MINISTRY OF SUPPLY/R.R.E. VALVE ELECTRONIC **CV2436-43**

Specification MOS/CV2436-CV2443 Issue 2, dated:- August, 1958. To be read in conjunction with K1001 and BS448	Security Specification: Unclassified Valve: Unclassified

AMENDMENT No.1

AMENDMENT No.2

CV 2436-CV 2443

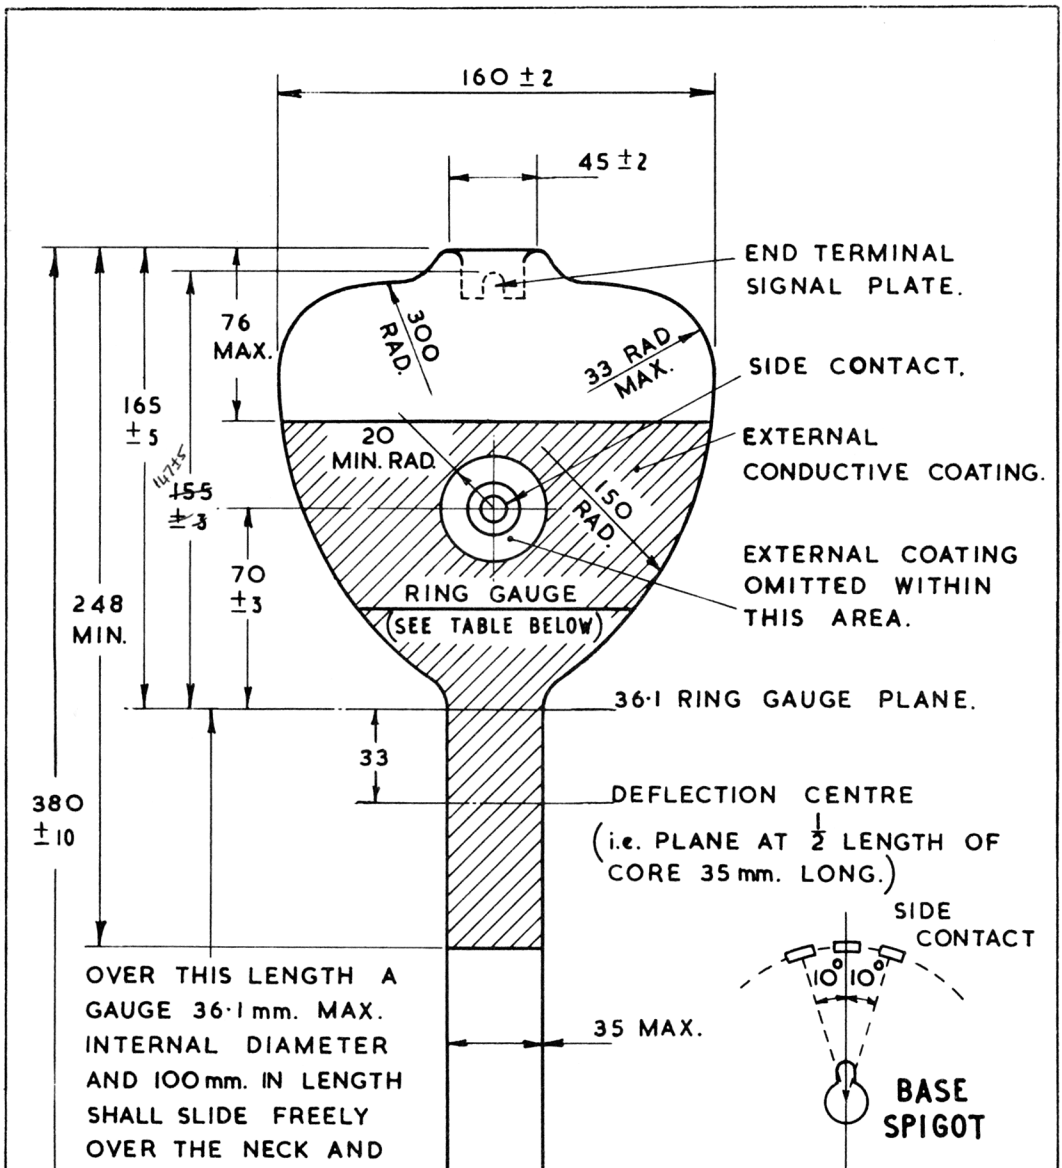
Page 5. Amend:- Distance between the end terminal and 36.1 ring gauge plane to read 147 ± 5 instead of 155 ± 3.
